DESIGN REVIEW BOARD

**June 9, 2026
7:00 PM**

**Town of Bay Harbor Islands, FLORIDA
Design Review Board
ADVISORY BOARD AGENDA ITEM REPORT**

AGENDA ITEM NO. 1

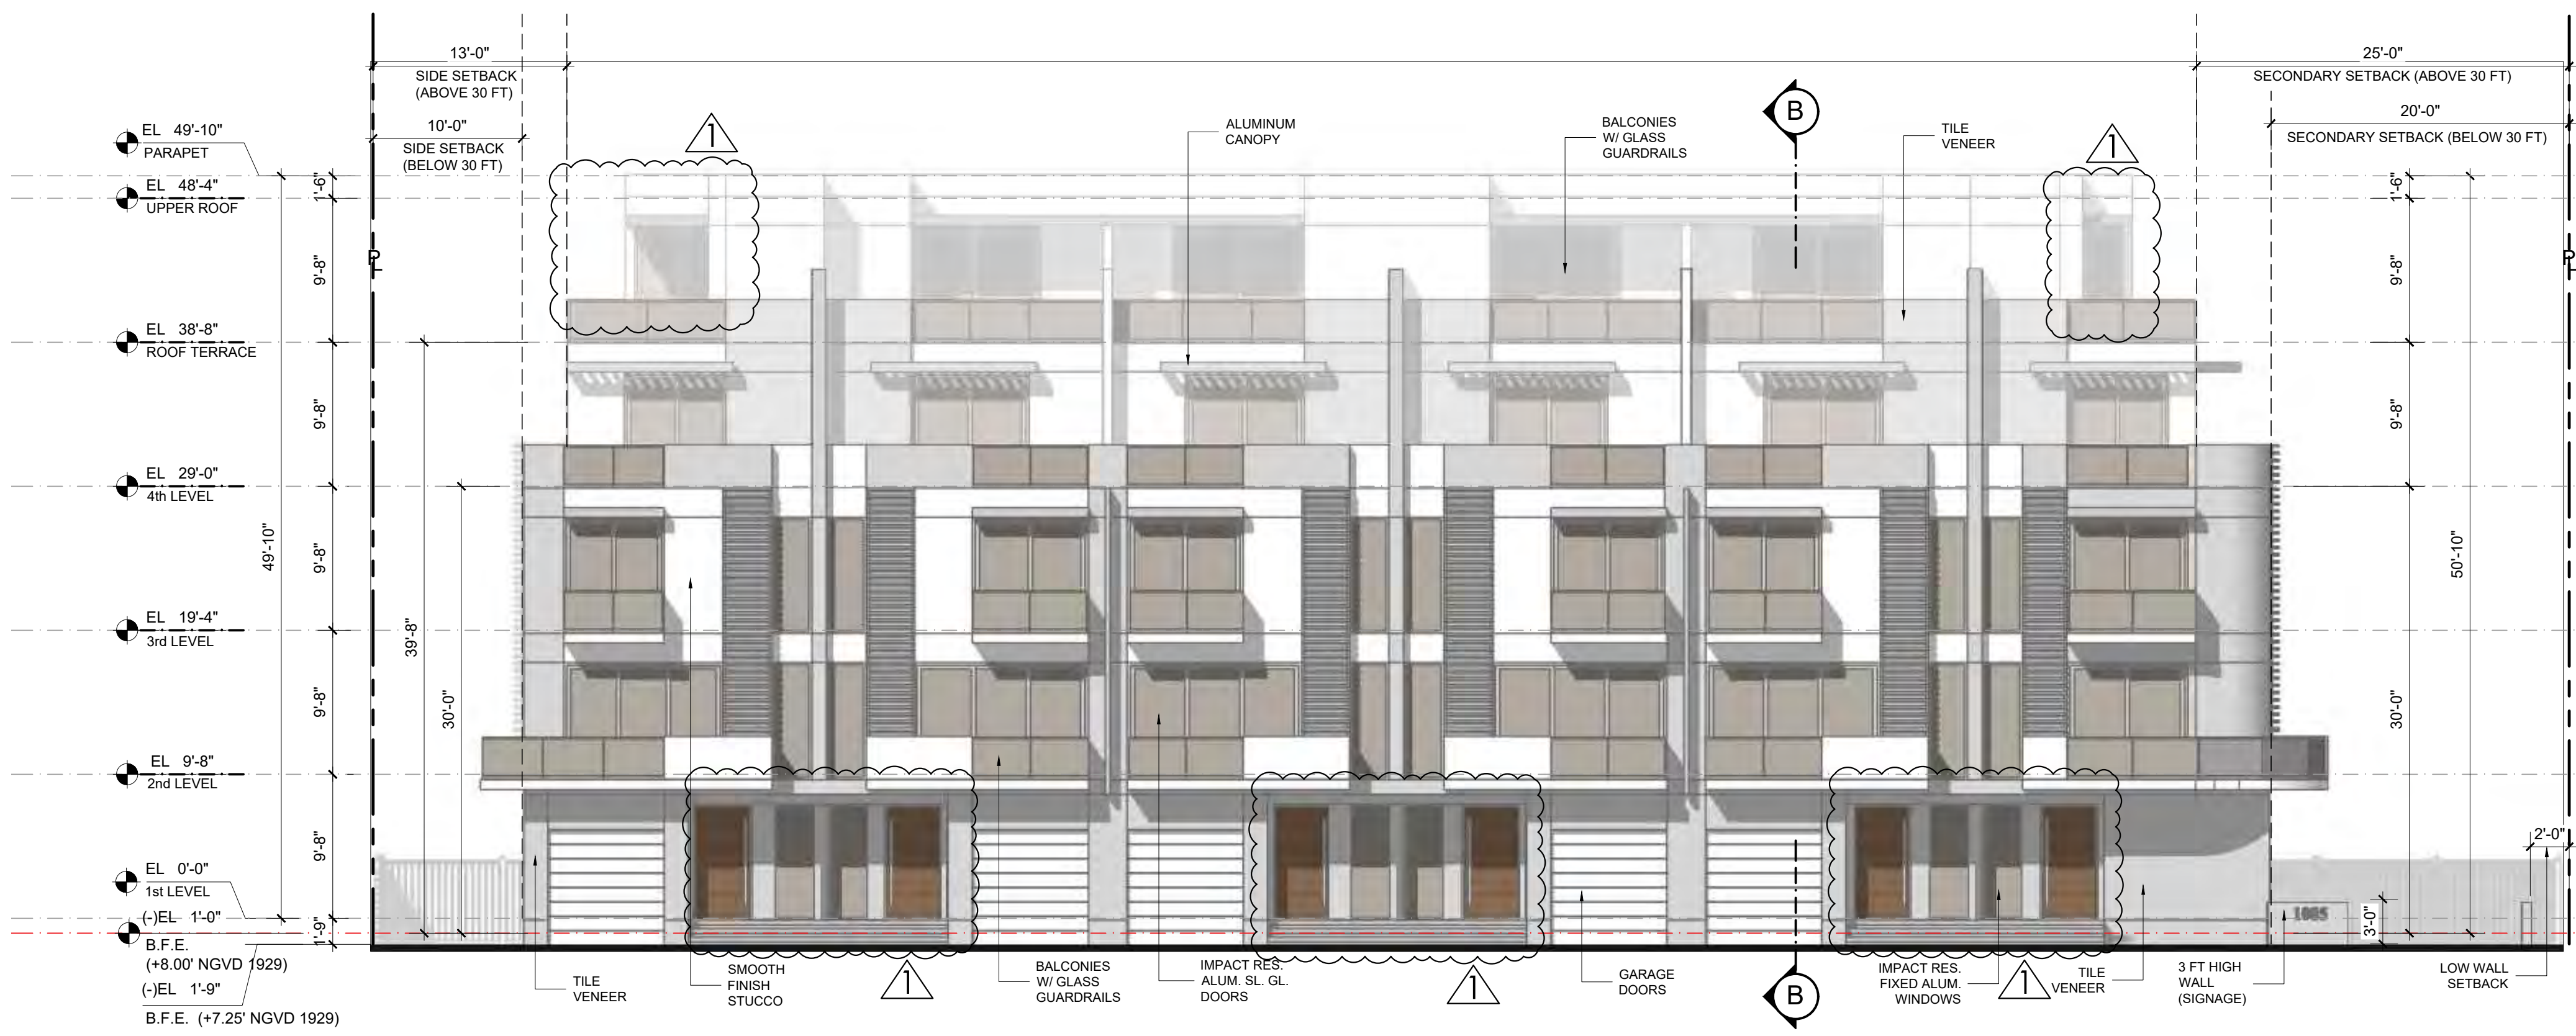
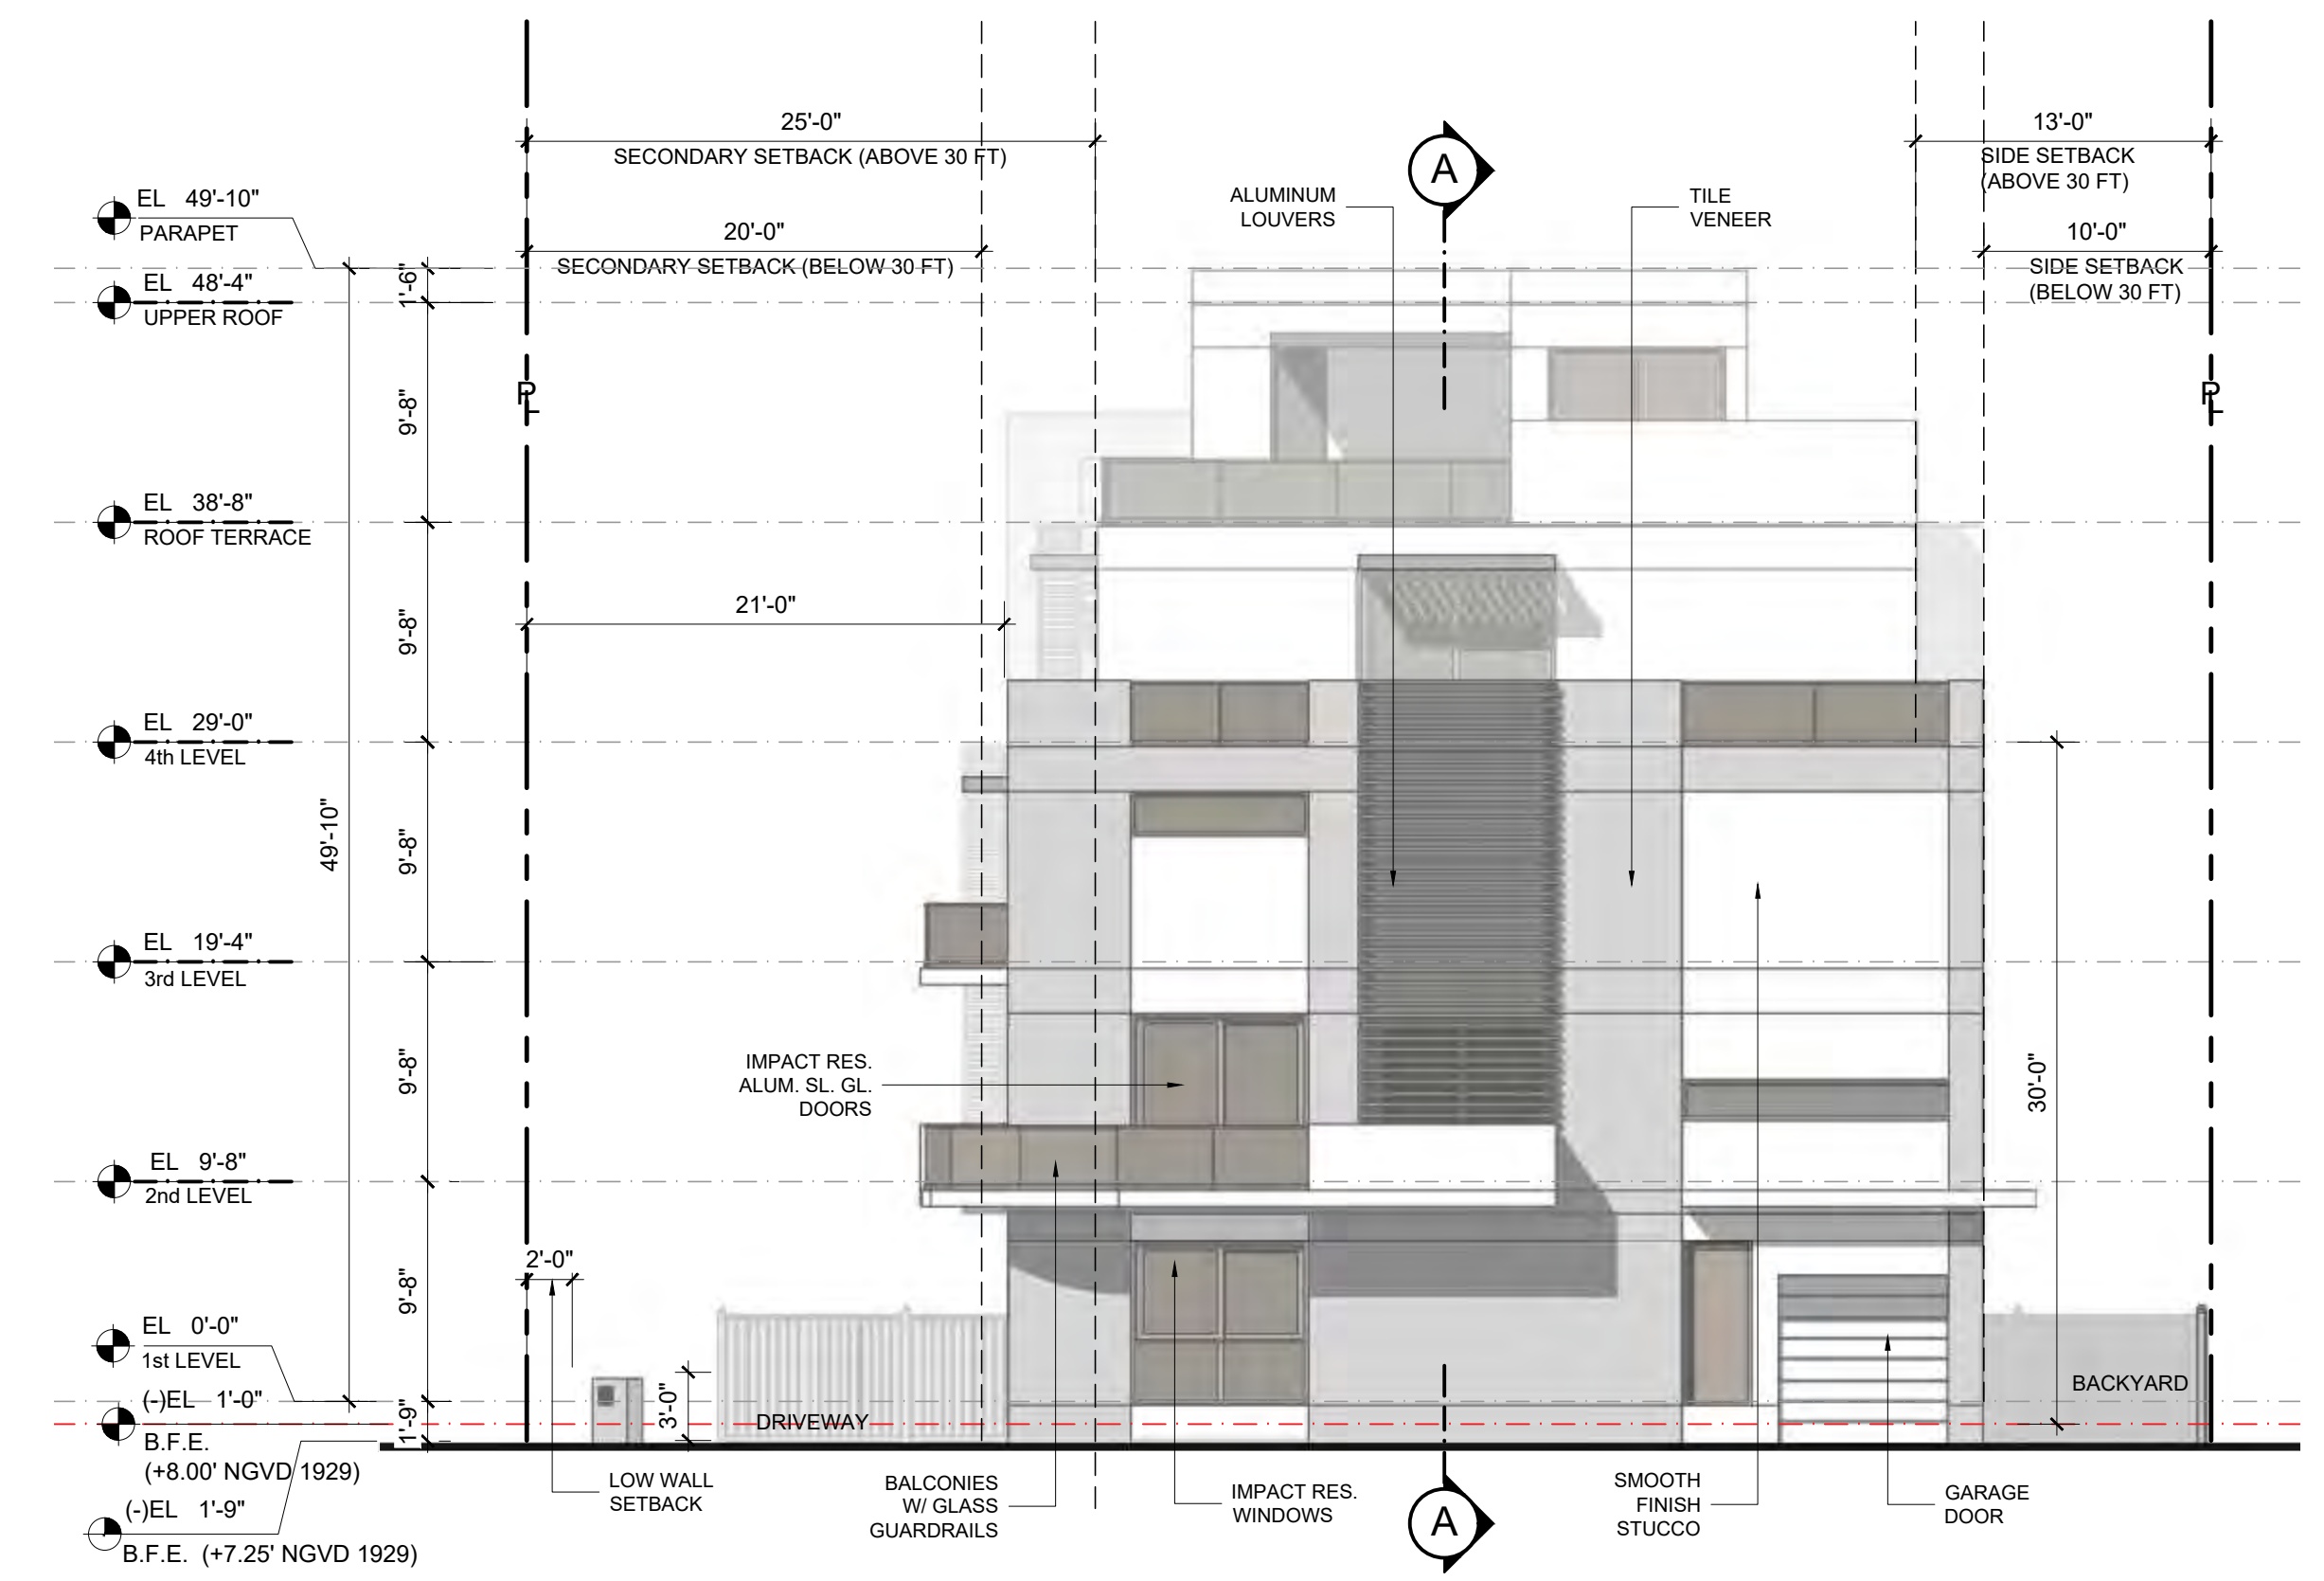
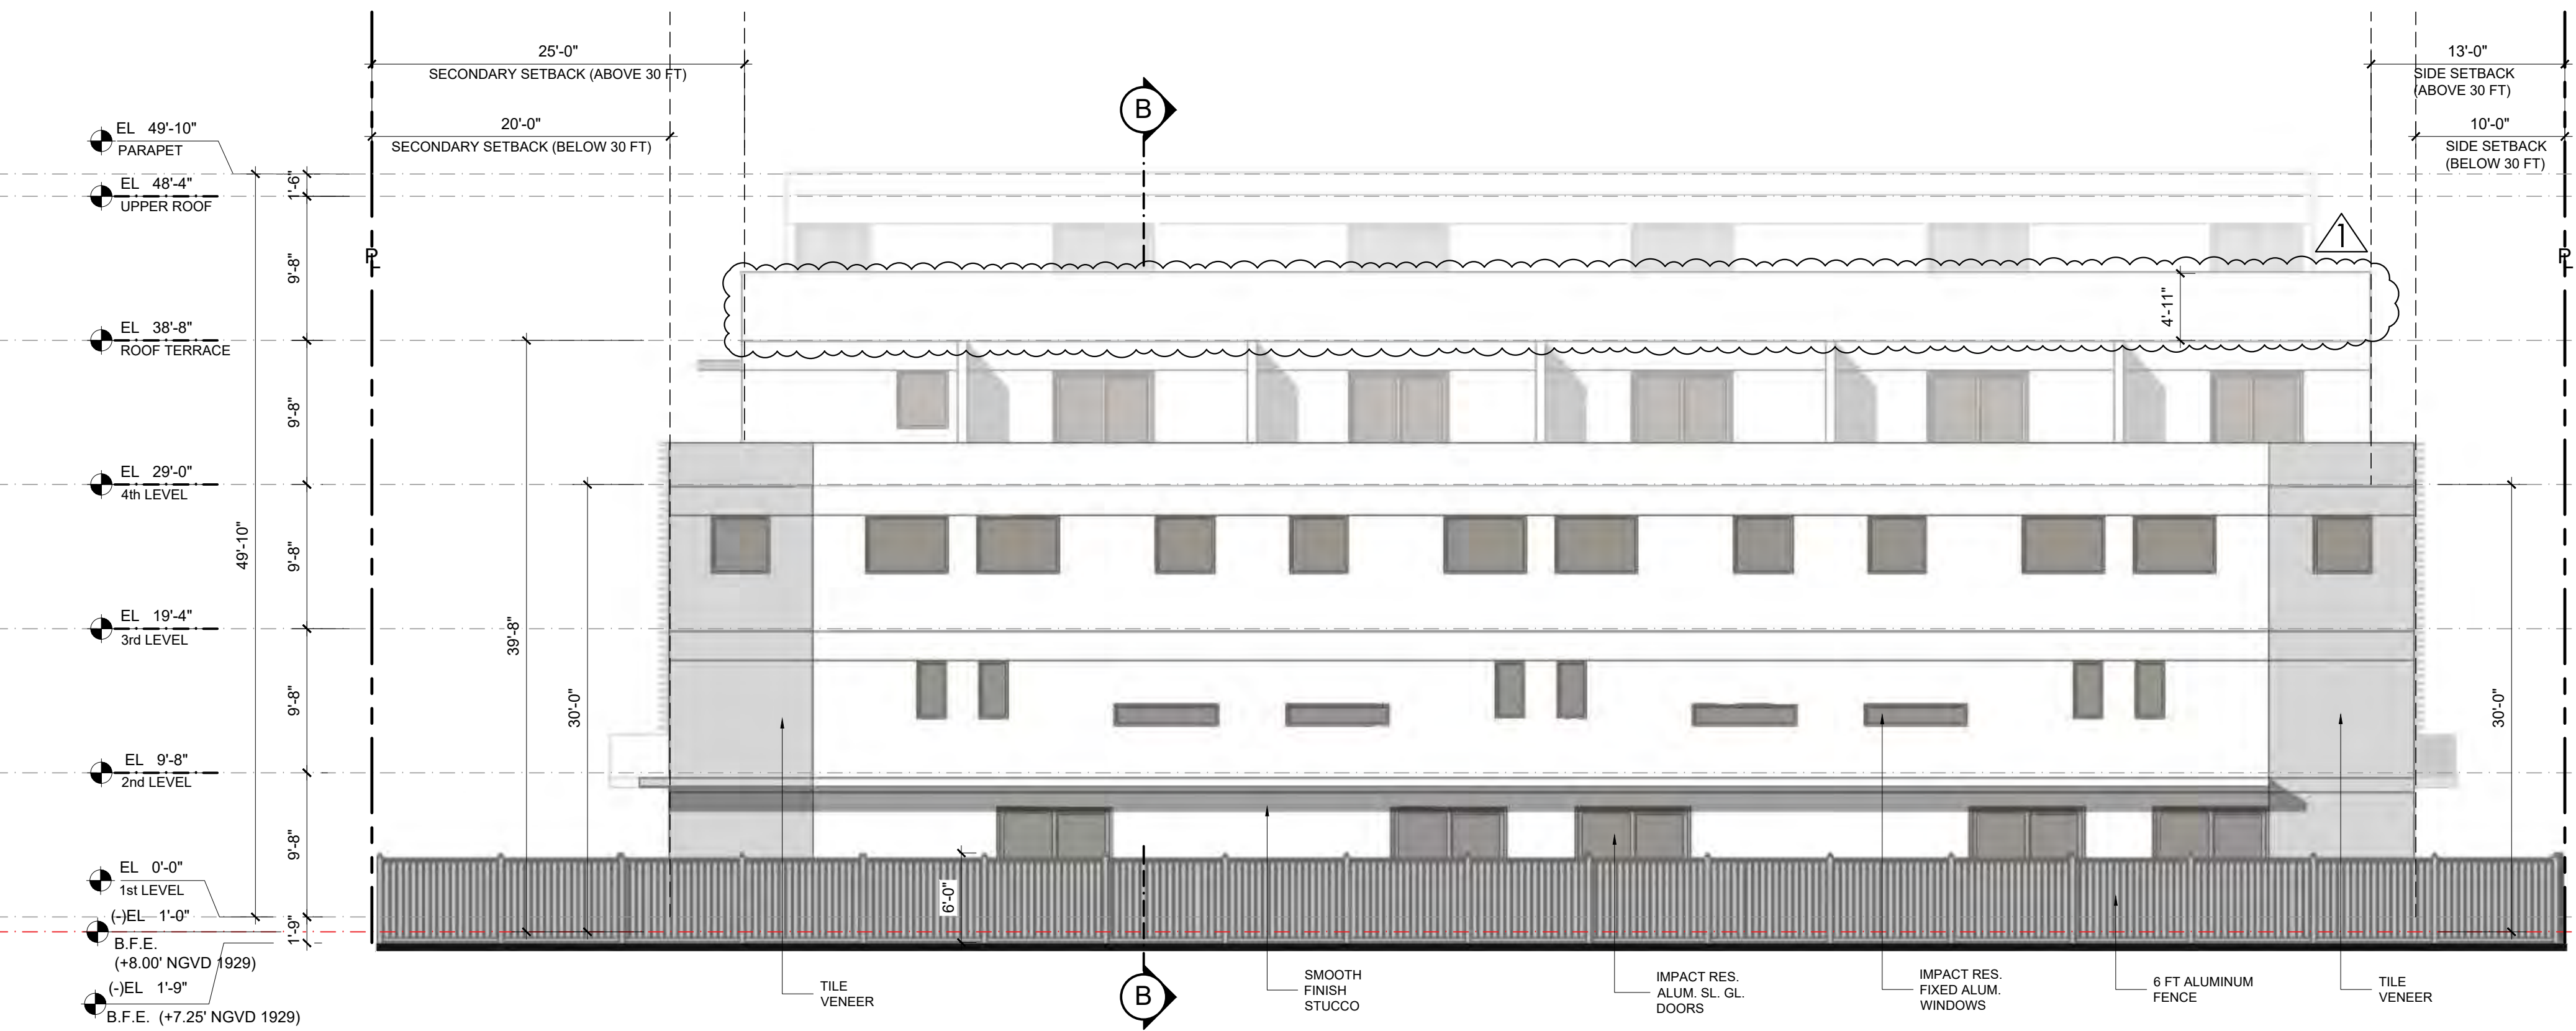
This item is brought back to the DRB for re-review due to exterior changes made by the applicant during the building permit review process that do not match the DRB-approved plans. Specifically, Sheet A-3.1 does not match the approved design, with doors and windows changed, window sizes altered, and a four (4) foot wide window removed on the first floor. The applicant did not request prior DRB approval for these changes. Staff identified the changes and consulted the DRB Chair, who confirmed that the project must return for review.

The applicant submitted permit plans that deviate from the DRB-approved design. While minor adjustments are typical during permit review, the following changes constitute a material change to the exterior appearance requiring DRB re-approval:

1. Doors: Doors have been changed from the approved design.
2. Windows: Window sizes have been changed from the approved design.
3. Windows: A four (4) foot wide window on the first floor has been removed.
4. Sheet A-3.1: This sheet does not match the DRB-approved design.

Recommended Action: Staff recommends that the Design Review Board review the proposed changes and, if found acceptable as submitted or with modifications, approve the Site Development Plan subject to the staff recommended conditions listed herein, or any additional changes or conditions felt to be necessary by the DRB.
